## addendum no. 02

project name & number: Fairbank Community Center Audio Visual Package  
40 Fairbank Road  
Sudbury, MA 01776

prepared by: Bargmann Hendrie + Archetype, Inc.

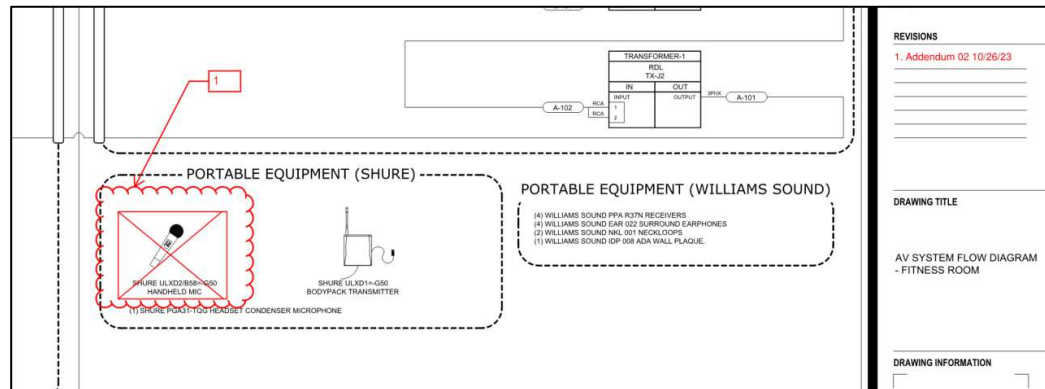
*The Audio-Visual Contractor shall provide the following system updates, including all equipment and labor, necessary for a complete and operational system.*

- 1. Multipurpose Room: Provide an XLR input and output (Mic Level) on a rack panel, connected to the audio DSP.*
- 2. Program Room 5: Provide an XLR input and output (Mic Level) on a rack panel, connected to the audio DSP.*
- 3. Training Rooms: Provide an XLR input and output (Mic Level) on a rack panel, connected to the audio DSP*
